**GEOTECHNICAL INVESTIGATION
HWY 3/MILLRACE BRIDGE REPLACEMENT
WAINFLEET, ONTARIO
W.P. 439-97-00**

**Project: SP2531
April 26, 1999**

**Re: Geotechnical Comments
Highway 3, Wainfleet**

From: Betty Bennett
To: MTOCR.DOWNSVCR.WongD
Date: 1999/02/03 10:55 am
Subject: Hwy 3 - Mill Race Bridge - Report Review

Abutment Cross-section

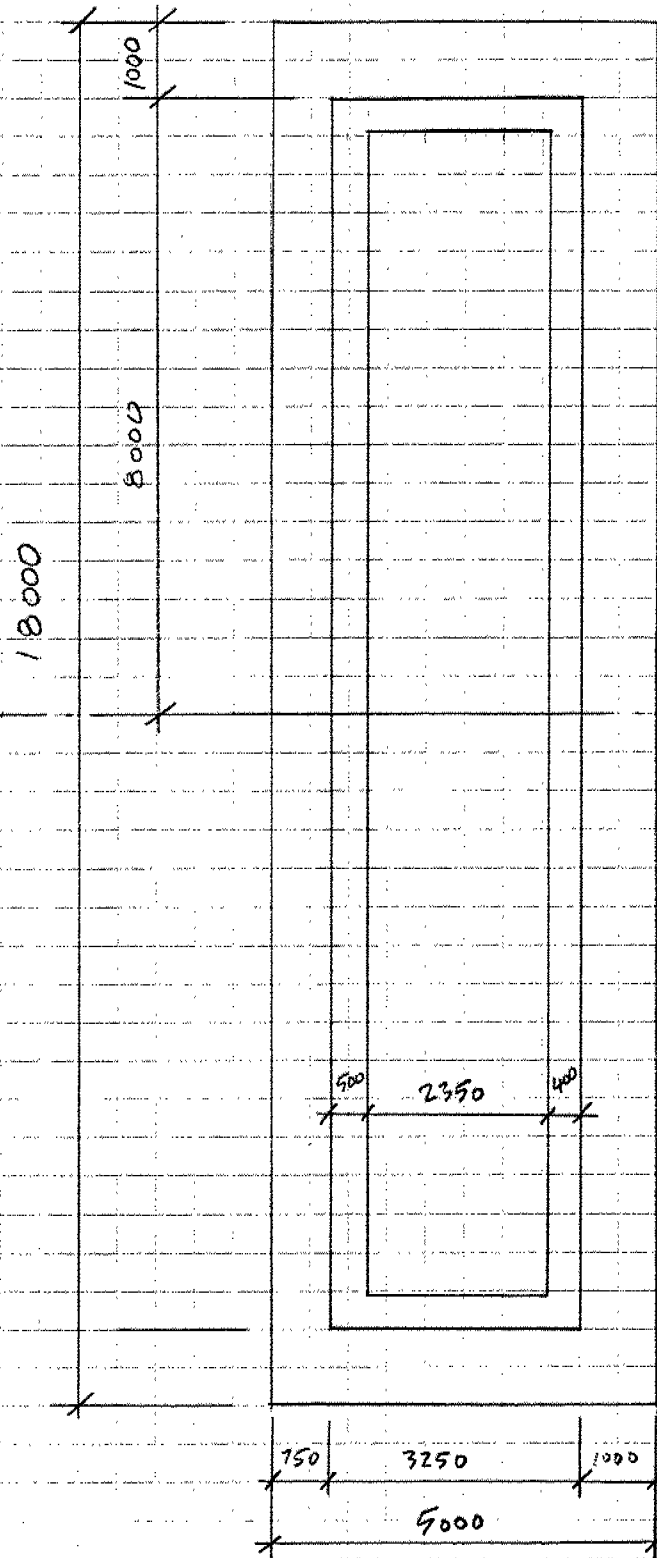
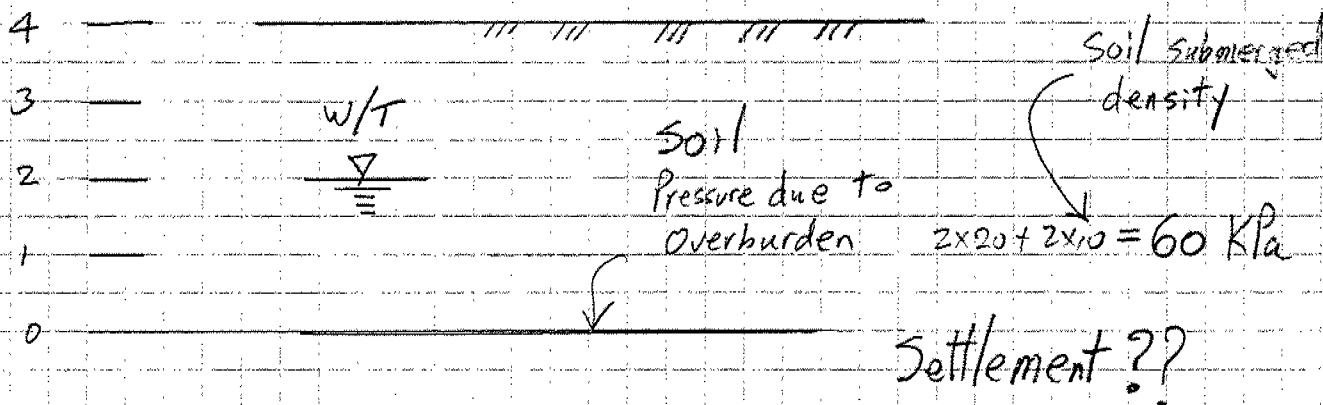
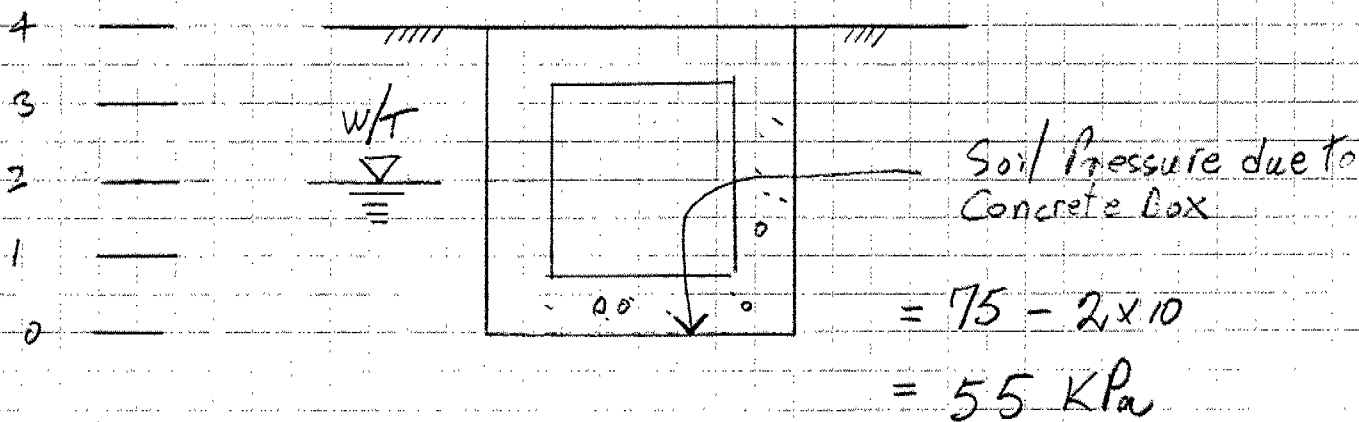
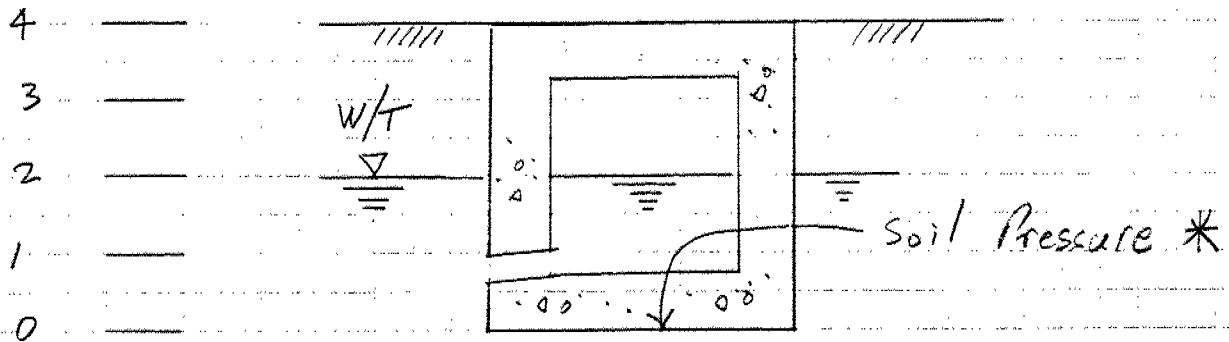
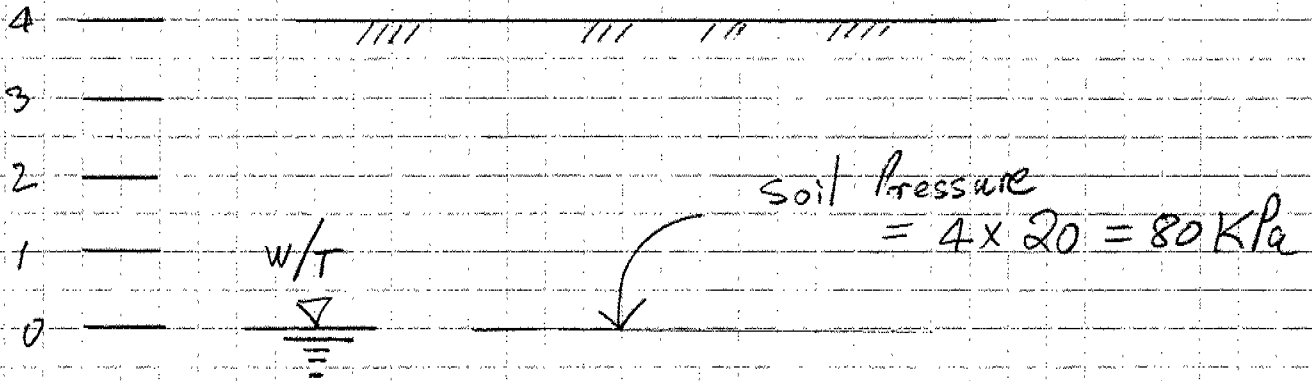
- I had a close look at the existing structure and worked out the soil pressures, which are 190 KPa at SLS and 295 KPa at ULS. Recognising the weak soil at this location, there is no sign of any settlement or problems associated with foundation failure of the existing structure for the last 60 years. We would have to justify why the soil capacity for the new structure constructed immediately behind the existing structure is limited to 70 KPa at SLS?

- In my proposal of a Cellular Abutment, the permanent load at SLS of 74 KPa is lower than the existing 4 m of soil overburden of 80 KPa. Since there is no increase of soil pressure, there should be no settlement as a result of the construction of this bridge. I have made up a hypothetical case of a concrete box being constructed in a location susceptible to settlement very similar to the construction of the proposed Cellular Abutment and demonstrated that there is no increase of effective pressure whether the box is COLOSED or DRAINED. If there is no net increase of effective pressure, there will be no agent to cause the settlement.

- If there is a general lowering of water table in this area in the future after the construction of this bridge, due to the increase of effective pressure, there will be some settlement. But this settlement will happen in the whole region and not limited to the area of newly constructed bridge and surely is not caused by the construction of this bridge. On the other hand, if for some reason, the water table rises, the pore water pressure will help to support the imposed load due

- to overburden and there will be no settlement. To my mind, regardless of the situation, the construction of this bridge with the Cellular Abutment will not cause settlement at this location.
- If settlement does not occur as a result of the construction of the Cellular Abutment, the determination of the geotechnical resistance (soil bearing pressure) should be based on factors other than on 25 mm settlement criterion.

CASE II A CLOSED Concrete Box constructed at this location

Settlement??

Settlement ??

If the general water table is lowered by 2 m, there will be an increase of effective soil pressure by 20 KPa. Under this scenario, there will be a settlement in the whole region whether the concrete box is constructed there or not.

Settlements for Various Footing Widths and Pressures Greater than Overburden Value
Project: J461/SP2531 Project Name: Mill Race Bridge Replacement

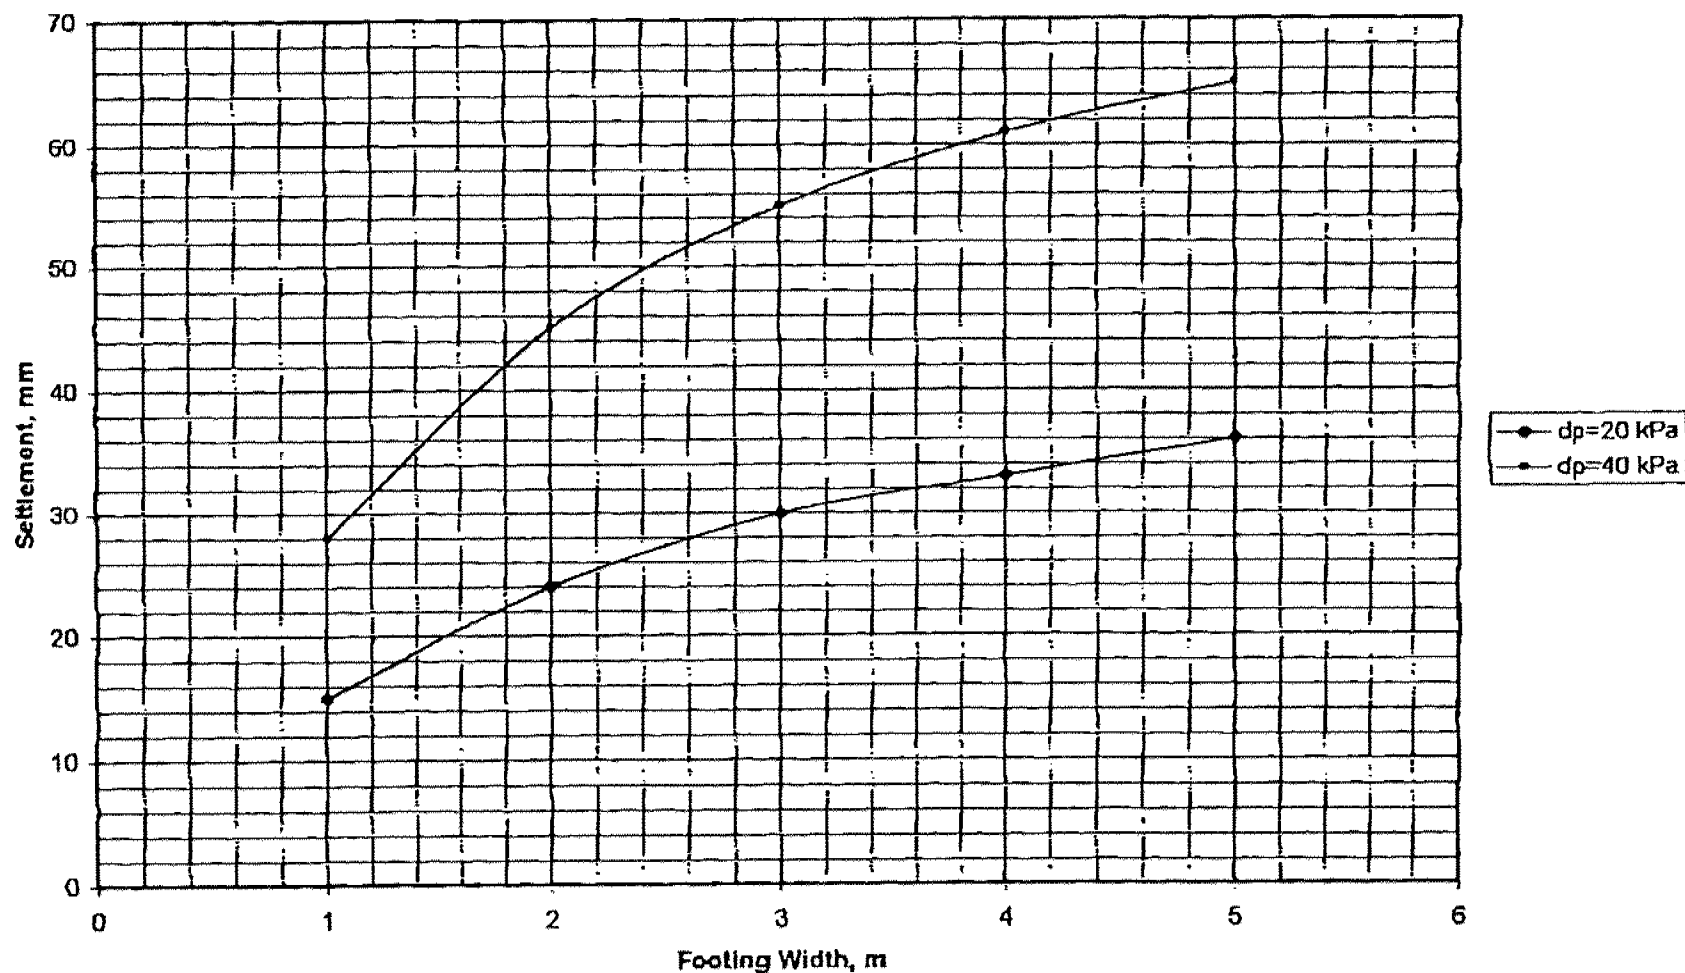
You have indicated cellular abutment with 5.0 m wide footing as an alternative. The geotechnical resistance of 80 kPa at SLS will result in a 36 mm total settlement and about 25 mm differential settlement. If the total settlement acceptable is 25 mm, then the geotechnical resistance can be reduced to 70 kPa at SLS. The geotechnical resistance at ULS is 95 kPa.

The geotechnical resistance at SLS (25 mm settlement value) is 80 kPa for a 2.2 m wide footing. The resistance value includes the overburden pressure of 60 kPa. A graph of settlement versus the footing width for geotechnical resistance values of 80 and 100 kPa is given in Drawing 1. The geotechnical resistance at ULS is 95 kPa. Based on these values, it is unlikely that the bridge can be supported on conventional foundations at the existing footing elevation of 171.2 m.
